Office Action Summary

10/798,487

DETAILED ACTION

angled side of bowl

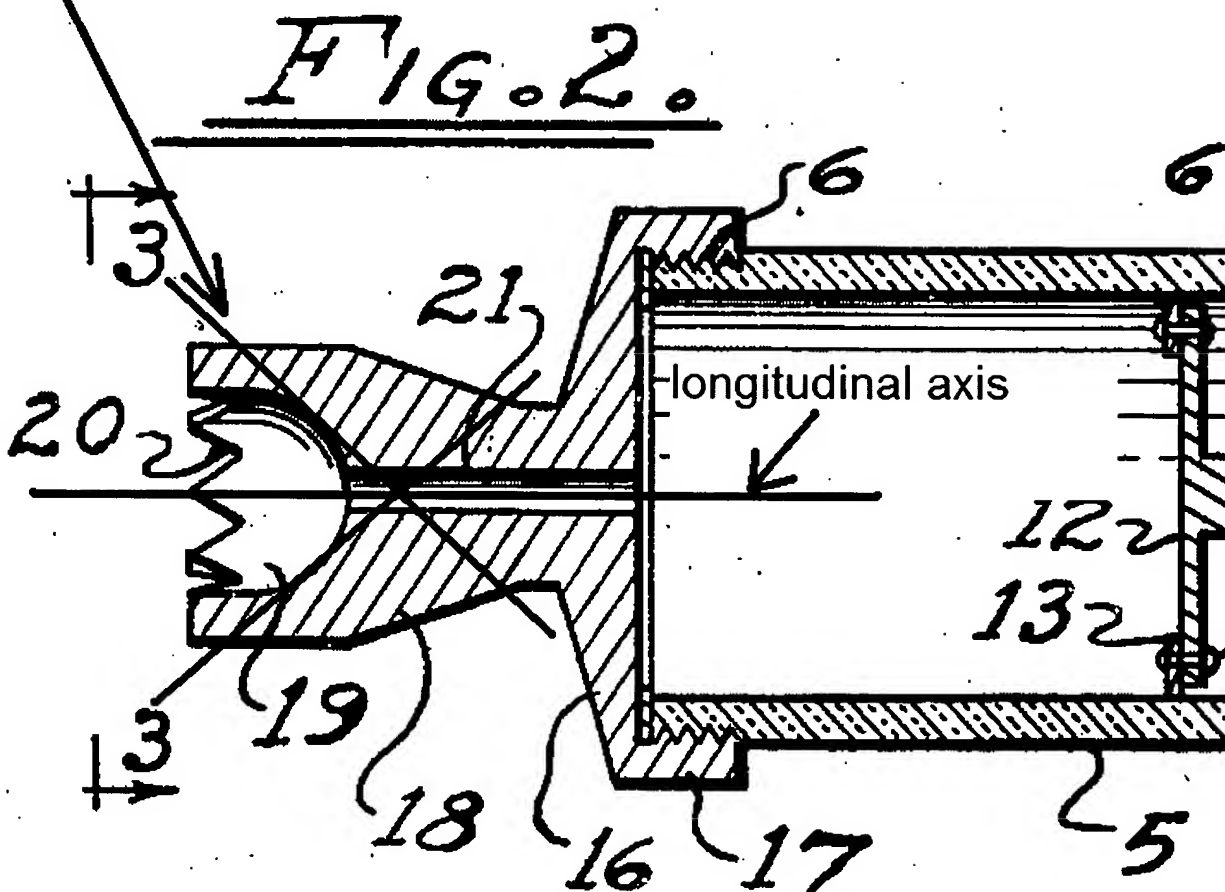
For claim 16, Bowman et al. as modified by Whitman (emphasis on Bowman) further teach the surface 19 comprises a bowl shaped element that is integral with the container.

For claim 17, Bowman et al. as modified by Whitman (emphasis on Bowman) further teach the bowl shaped element is angled with respect to the longitudinal axis of the container. See below.

For claim 18, Bowman et al. as modified by Whitman (emphasis on Bowman) further teach the angled being within a range of about plus 45 degrees to about minus 45 degrees. See below.
